4.3 Building B elevations

Building B north-west elevation current proposed changes

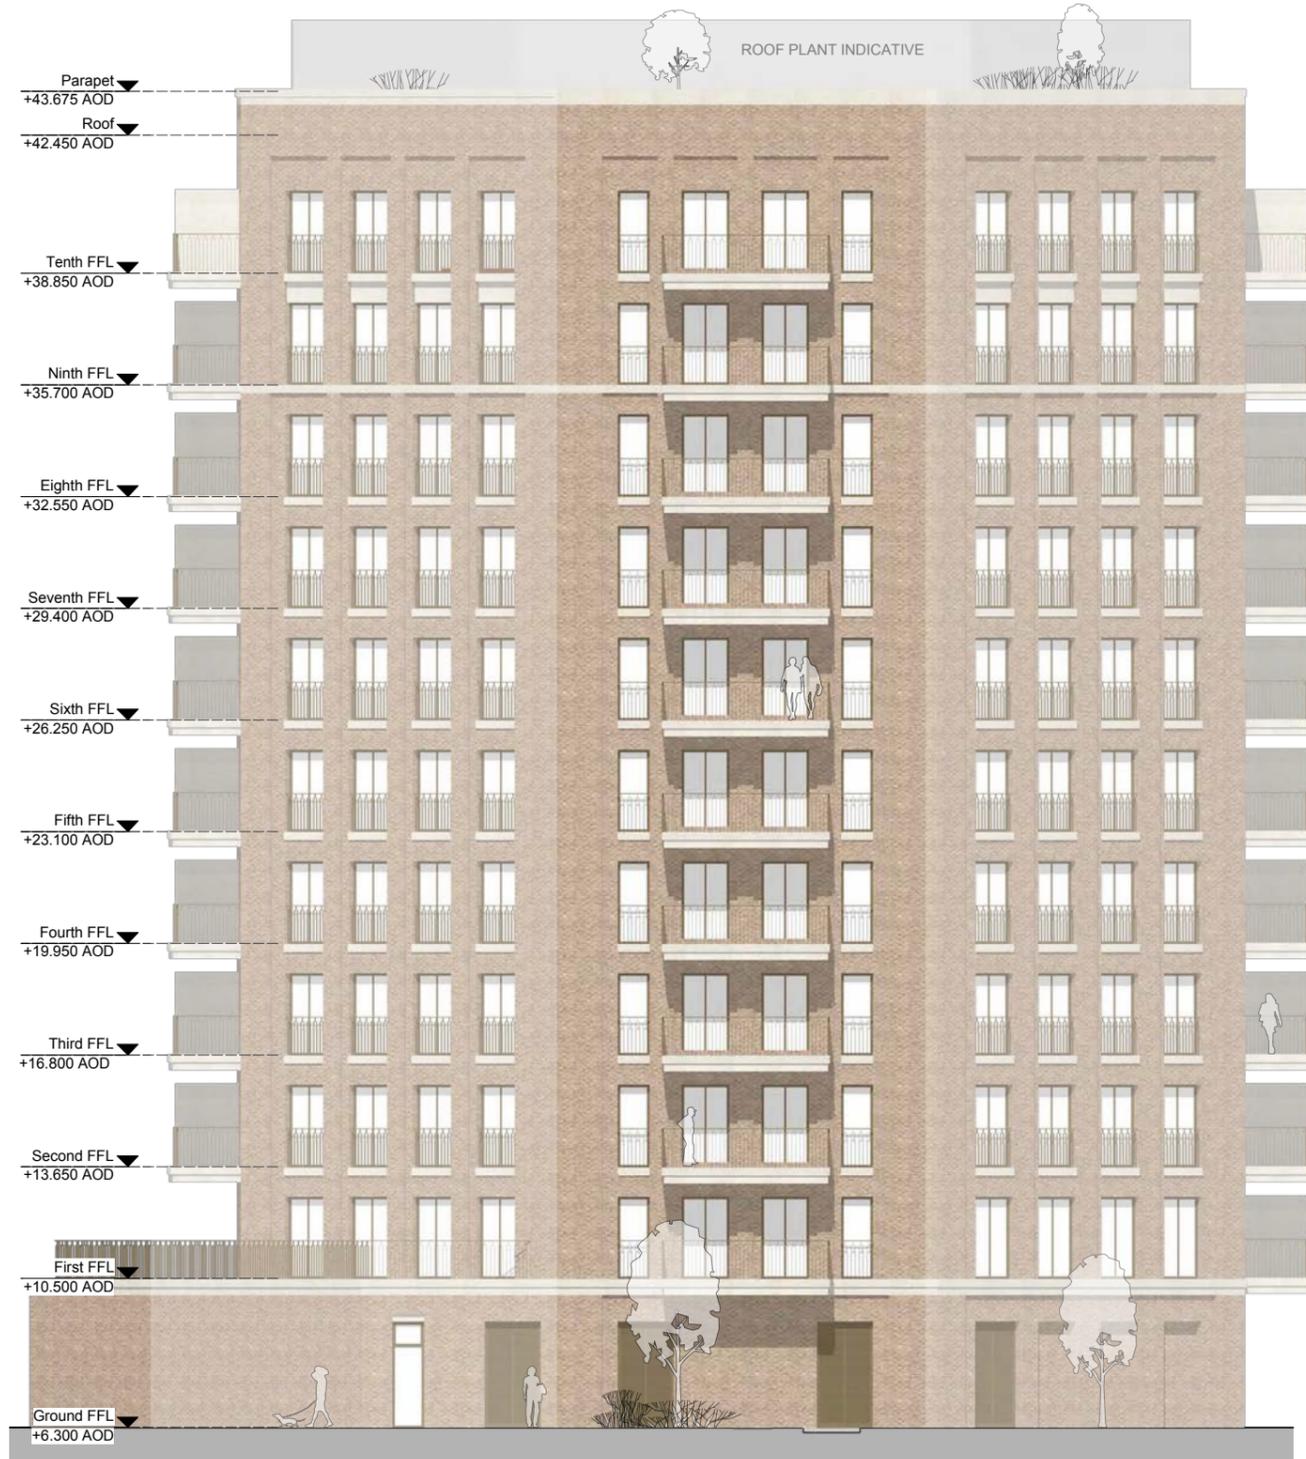
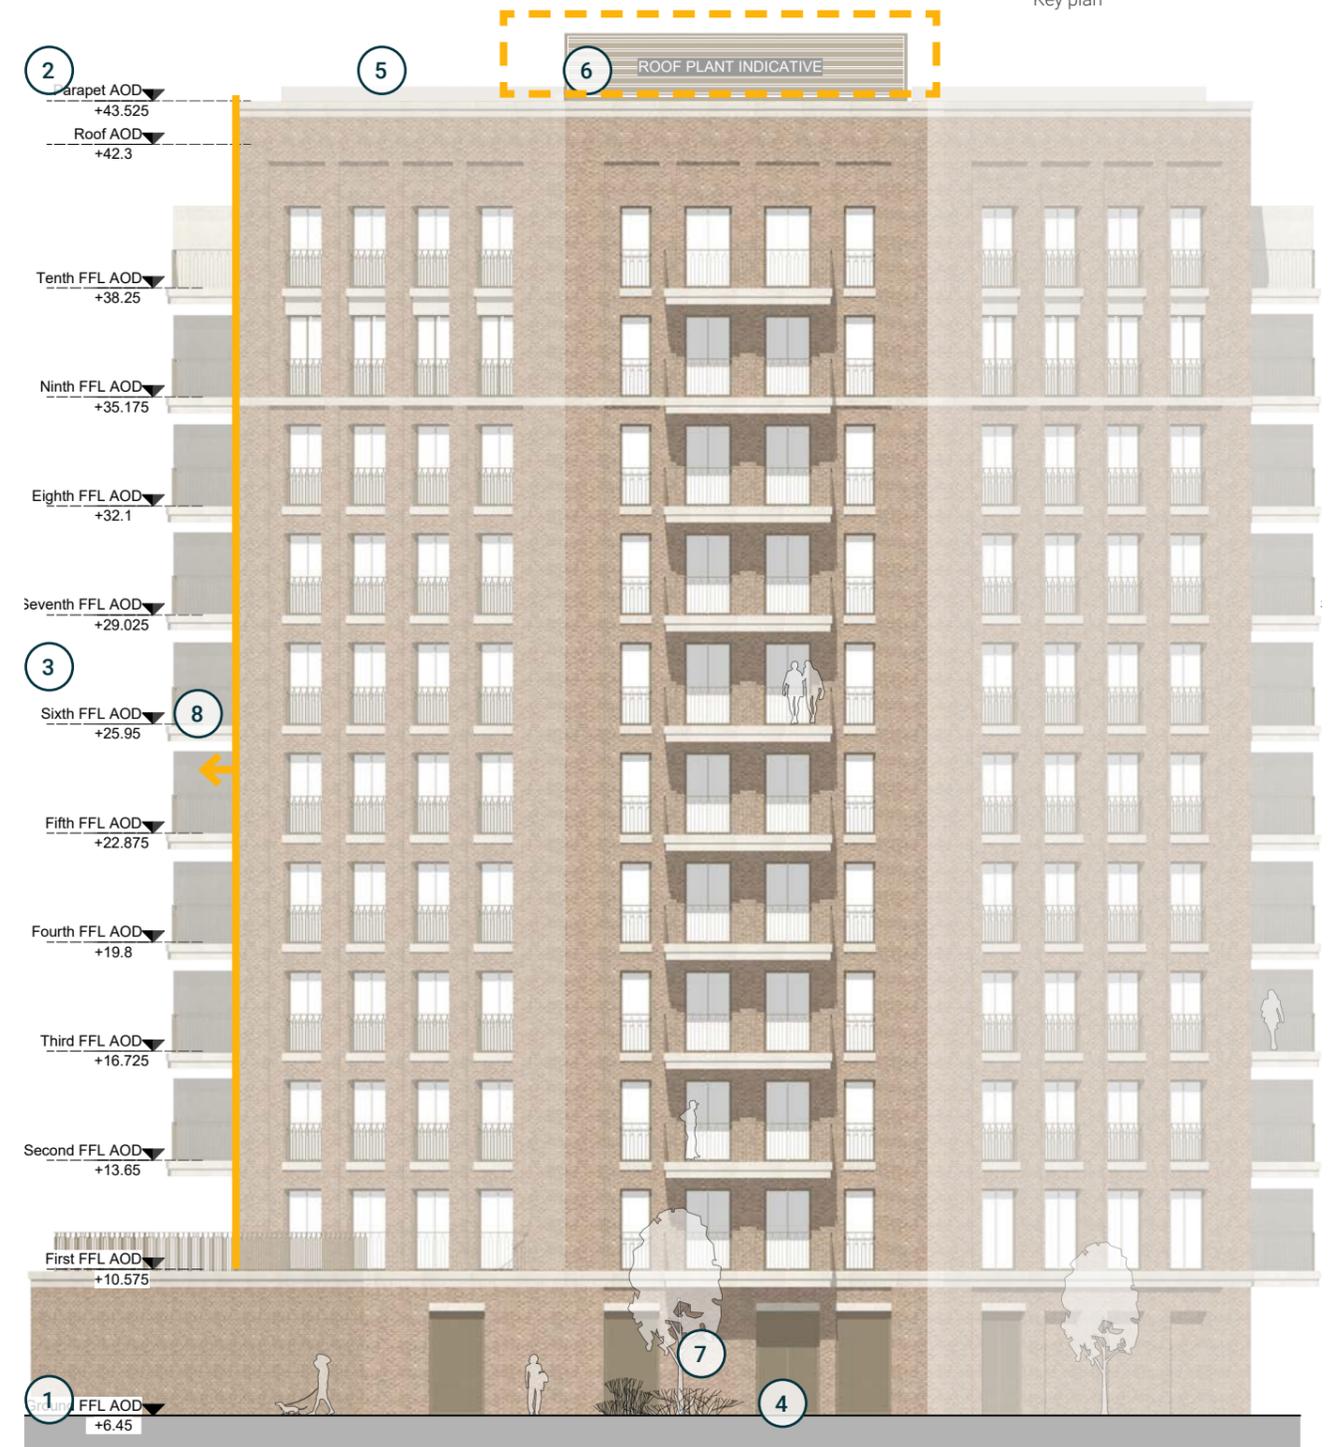
- 1 Ground floor FFL increased by 15cm from +6.3 to +6.45
- 2 Parapet height reduced by 15cm (from +43.675 to +43.525)
- 3 Floor to floor heights (1st to 10th floors) each reduced by 7.5cm
- 4 New escape door for means of escape from stair core and adjustments to doors for bin stores, bike stores and plant rooms accordingly
- 5 Residential terrace removed
- 6 Roof plant enclosure consolidated
- 7 Arrangement of external doors amended to current proposed ground floor layout.
- 8 a 112.5mm (or 11.25cm) extension in building footprint to the north

Building B north elevation current proposed changes

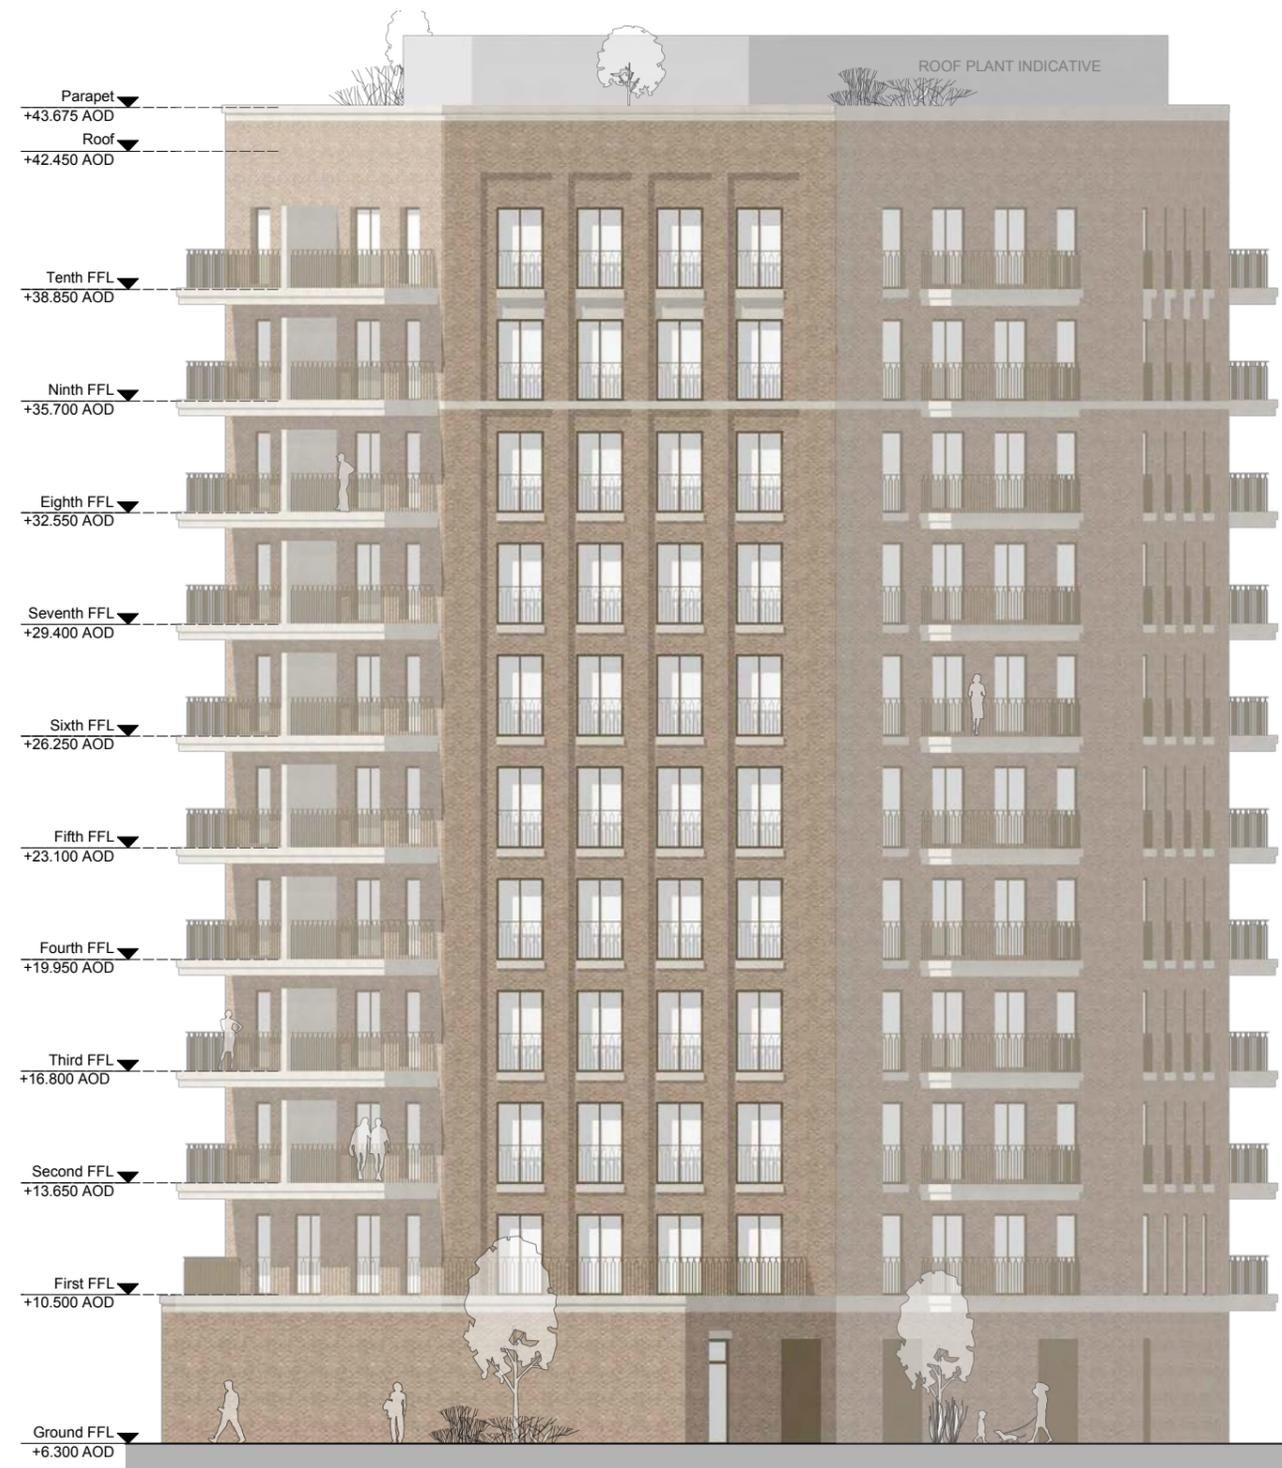
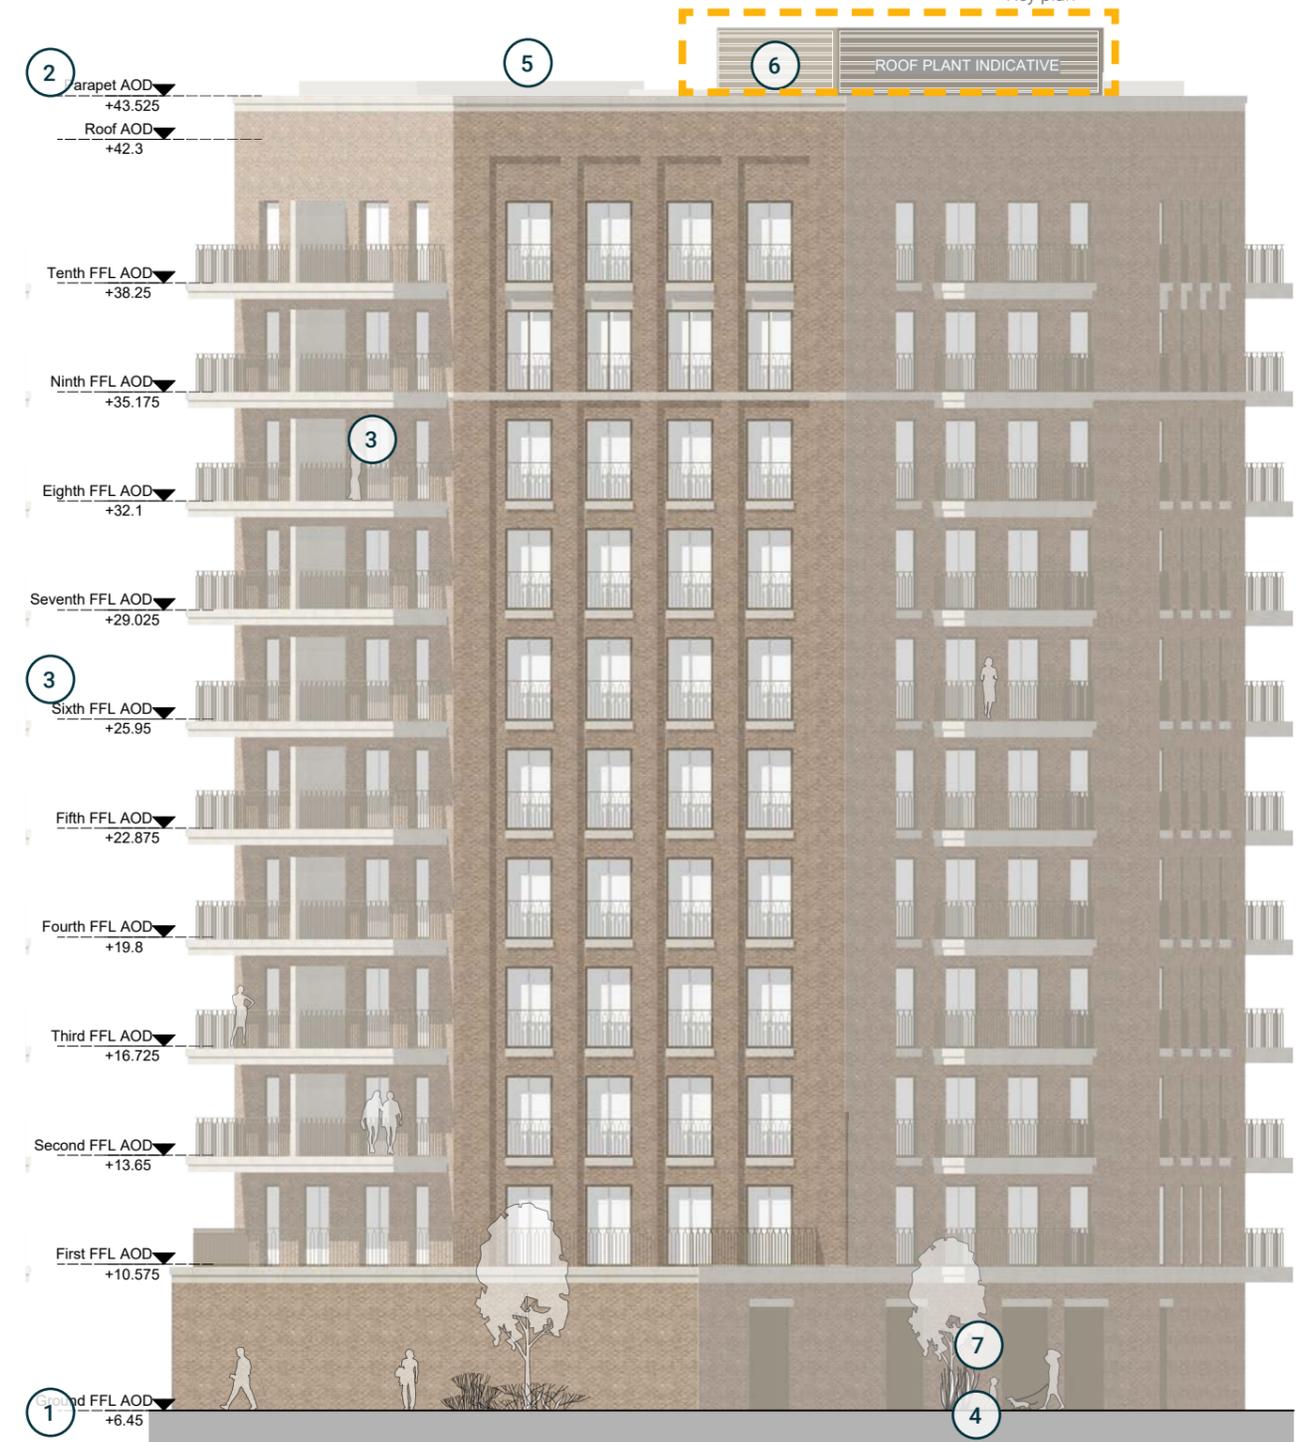
- 1 Ground floor FFL increased by 15cm from +6.3 to +6.45
- 2 Parapet height reduced by 15cm (from +43.675 to +43.525)
- 3 Floor to floor heights (1st to 10th floors) each reduced by 7.5cm
- 4 New escape door for means of escape from stair core and adjustments to doors for bin stores, bike stores and plant rooms accordingly
- 5 Residential terrace removed
- 6 Roof plant enclosure consolidated
- 7 Arrangement of external doors amended to current proposed ground floor layout.
